Subject: RE: DA 2021 2617 25 CARRINGTON PARADE FRESHWATER NSW 2096
WRITTEN SUBMISSION: LETTER OF OBJECTION SUBMISSION: MEALE

RE: DA 2021 2617 25 CARRINGTON PARADE FRESHWATER NSW 2096
WRITTEN SUBMISSION: LETTER OF OBJECTION
SUBMISSION: MEALE

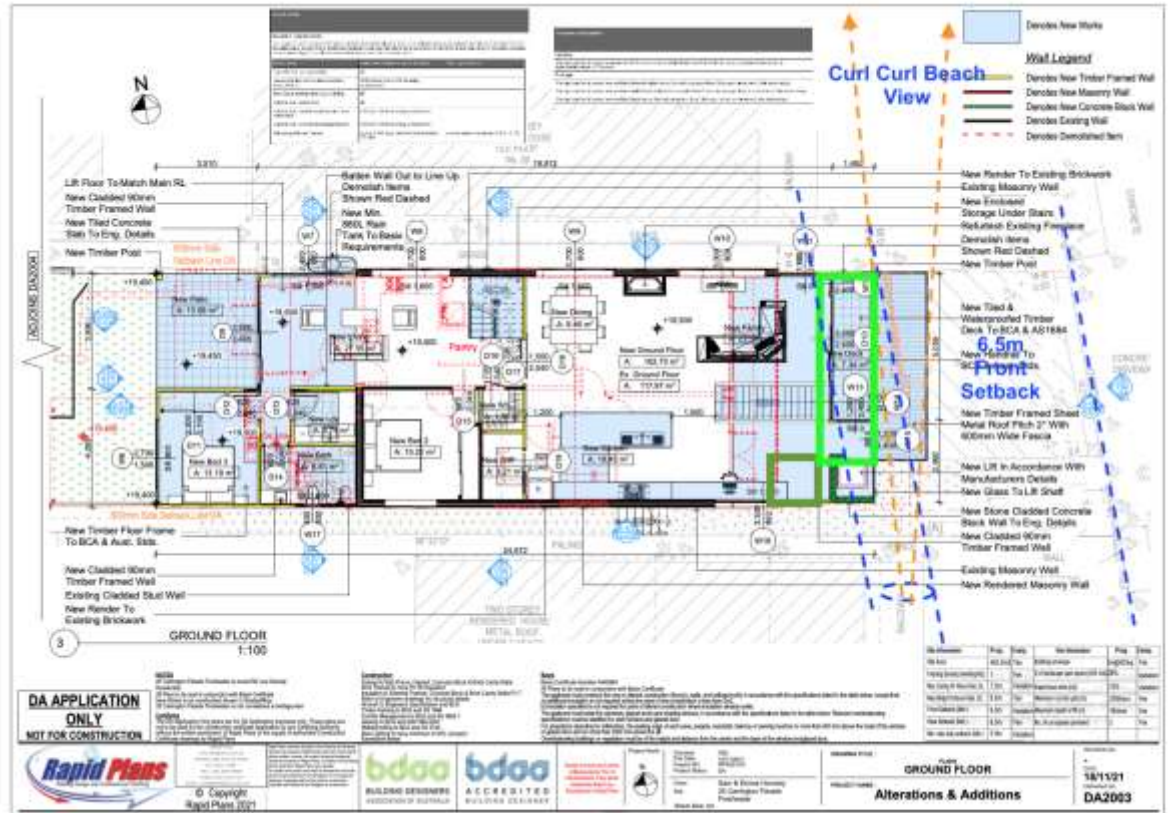
“Are the impacts consistent with impacts that may be reasonably expected under the controls? For non-complying proposals the question cannot be answered unless the difference between the impacts of a complying and a non-complying development is quantified.”

The impacts are not consistent with the impacts that would be reasonably expected under the controls.

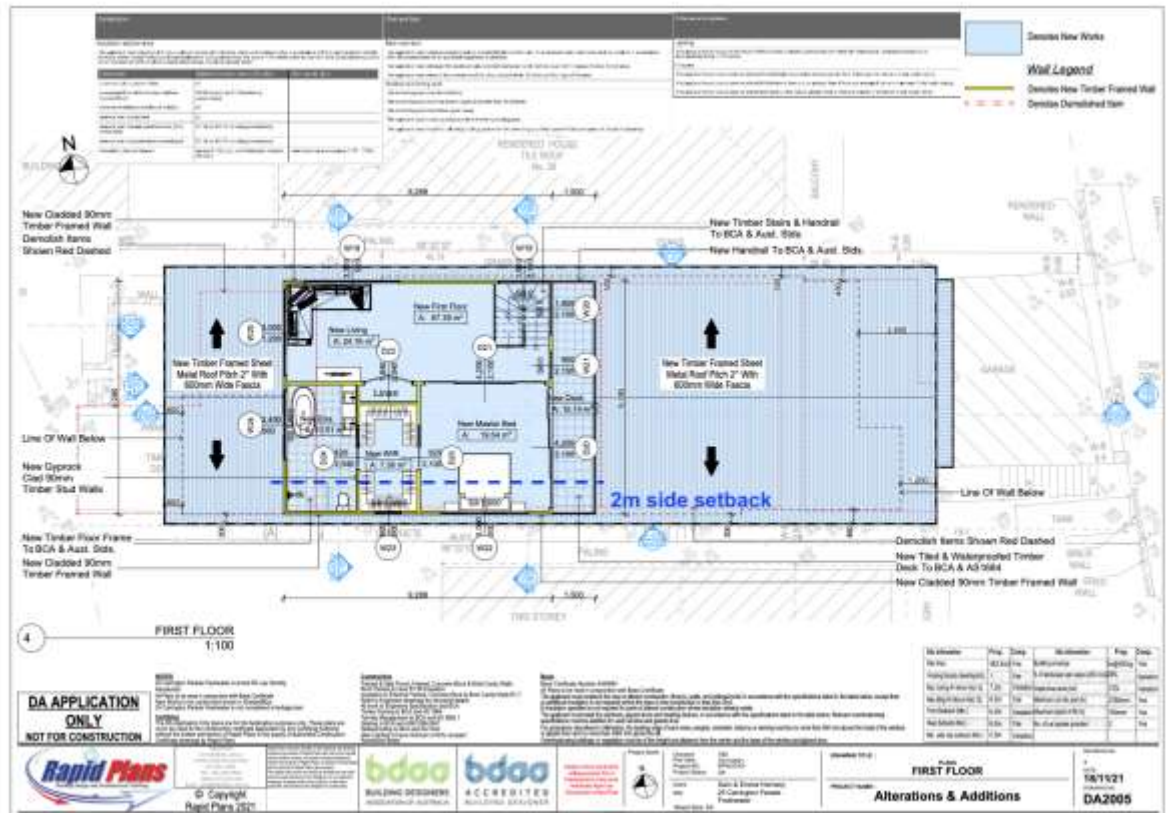
Marked up DA Drawing Ground Floor: Delete all built form in the 6.5m front setback zone at the Ground Floor, to better accord with B7 Front Boundary Setbacks. Reposition the proposed eastern 1.8m wide deck at the Ground Floor to be to the west of the 6.5m front setback zone [as green rectangle above], to equal the same compliant front setback of the eastern deck of the neighbour at #24 Carrington. Reposition the eastern external wall alignment to the Ground Floor to have a minimum front setback of 8.8m to equal the same 8.8m minimum front setback of the eastern wall zone of neighbour at #24 Carrington, to better accord with B7 Front Boundary Setbacks. Reposition the roof over the eastern external wall alignment to the Ground Floor to have a minimum front setback of 8.2m to equal the same 8.2m minimum front setback of the eastern wall zone of neighbour at #24 Carrington, to better accord with B7 Front Boundary Setbacks

- Delete all built form in the 6.5m front setback zone at the Ground Floor, to better accord with B7 Front Boundary Setbacks
- Reposition the proposed eastern 1.8m wide deck at the Ground Floor to be to the west of the 6.5m front setback zone, to equal the same compliant front setback of the eastern deck of the neighbour at #24 Carrington. No deck within the front 6.5m setback zone, to better accord with B7 Front Boundary Setbacks
